**TOWN OF NEWBURGH  
PLANNING BOARD  
TECHNICAL REVIEW COMMENTS**

**PROJECT NAME:** PRESTIGE HOMES LOT LINE CHANGE  
**PROJECT NO.:** 24-30  
**PROJECT LOCATION:** SECTION 53, BLOCK 2, LOT 10 & 11  
**REVIEW DATE:** 10 OCTOBER 2024  
**MEETING DATE:** 17 OCTOBER 2024  
**PROJECT REPRESENTATIVE:** ZEN CONSULTANTS, INC.

**SEPTIC SYSTEM DESIGN DATA:**

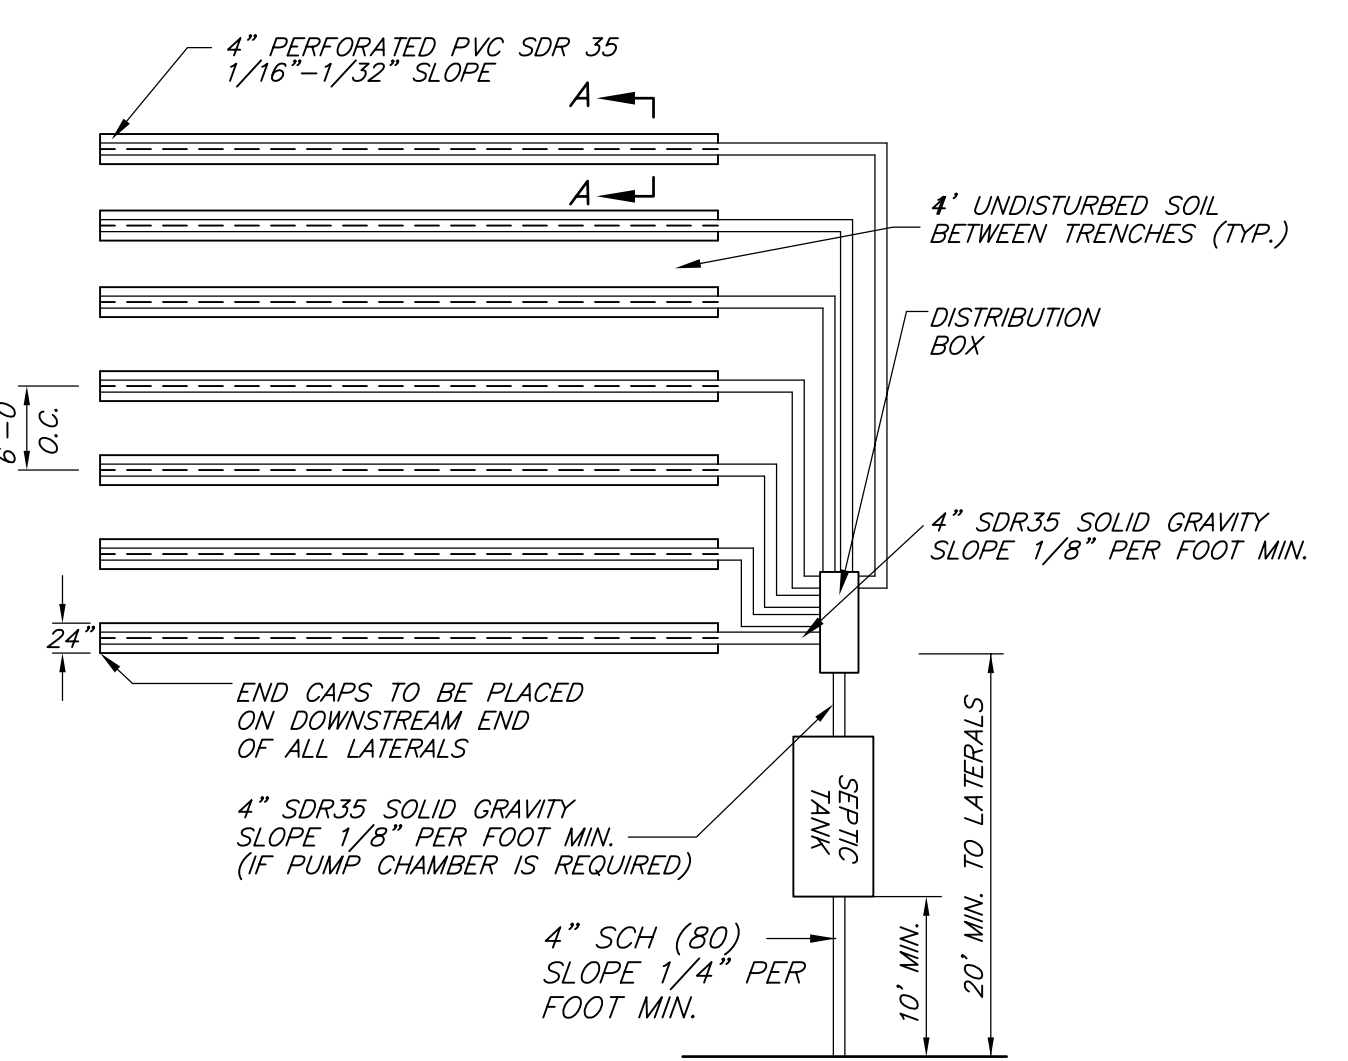
5. Driveway locations must be approved by the Highway Superintendent.
6. Compliance with the Town’s Tree Preservation Ordinance must be documented.
7. Septic system design Data Chart should identify the absorption fields as proprietary Elgin systems.

**TYPICAL SECTION OF ELJEN IN-DRAIN SYSTEM**  
N.T.S.

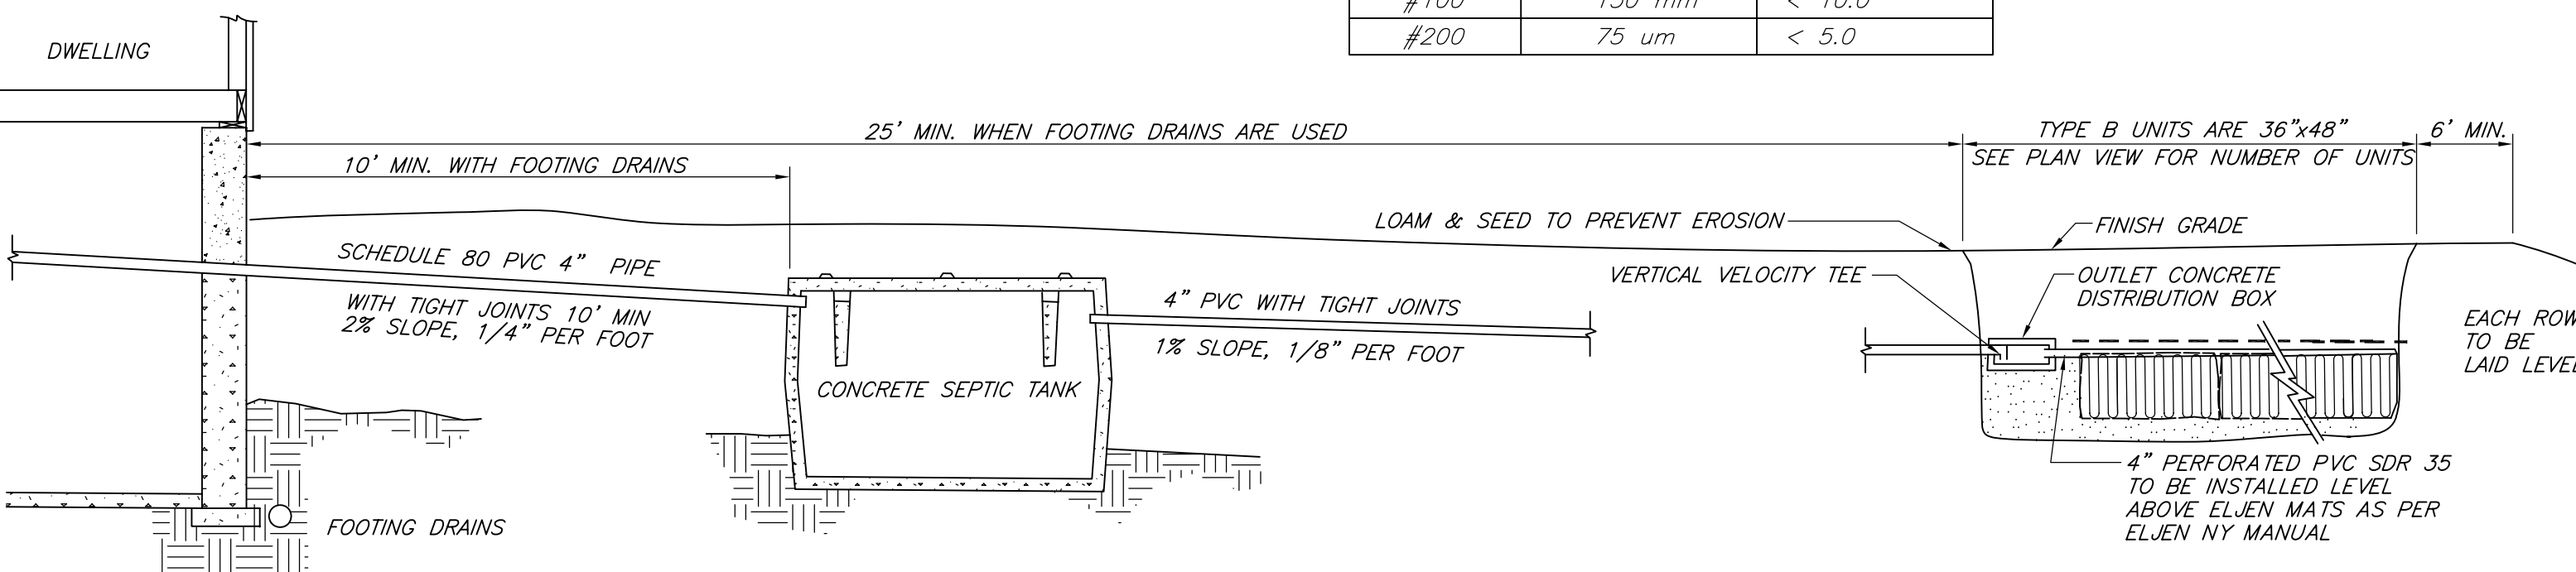
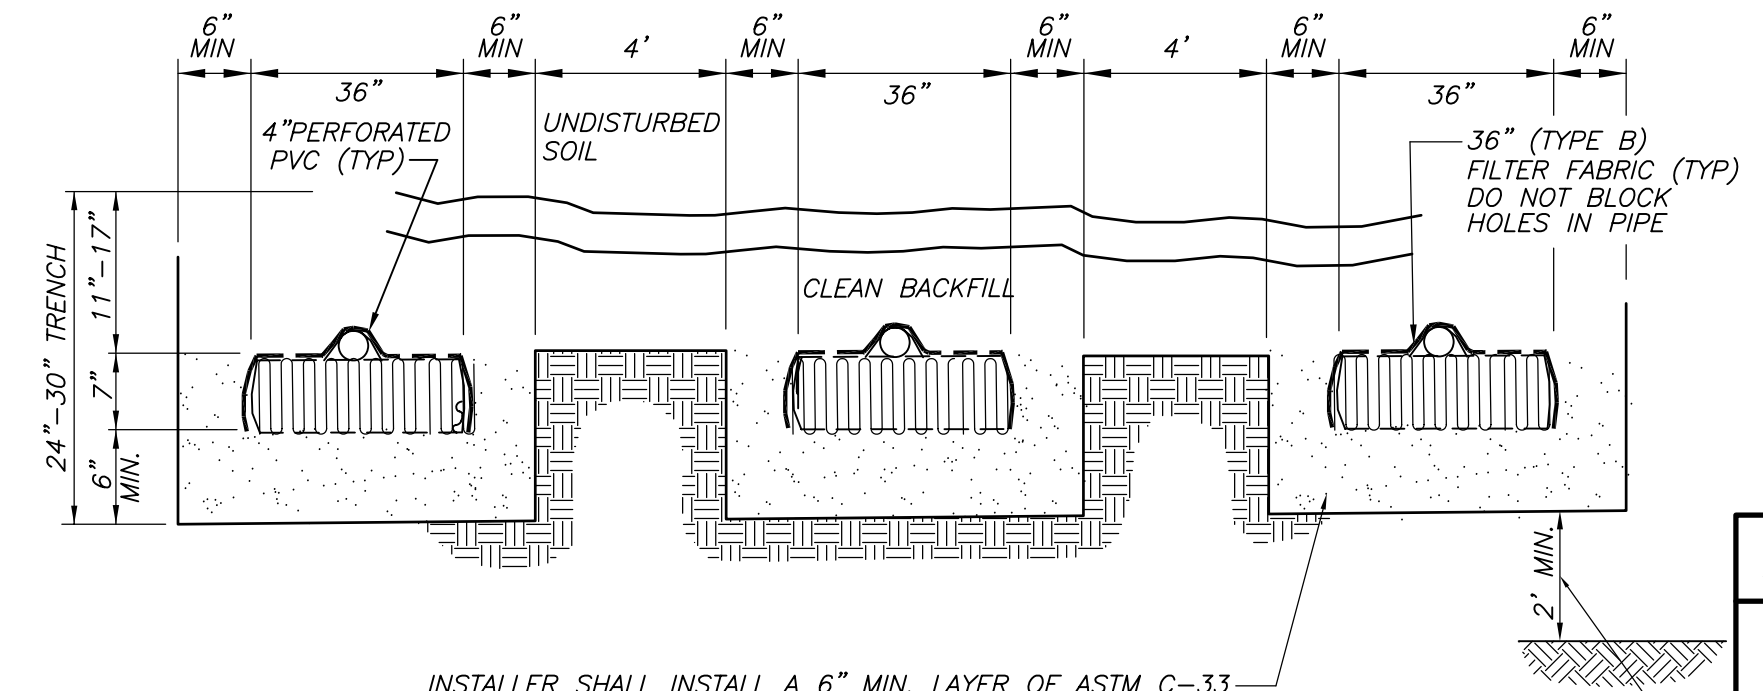
8. Shallow absorption trench system notes are identified on the plans. Details do not identify shallow absorption trench systems proposed. Soil testing identifies soil acceptable for conventional installations. If shallow absorption trench systems are proposed appropriate details should be added to the plans and a Grading Plan for the shallow absorption trench should be provided.
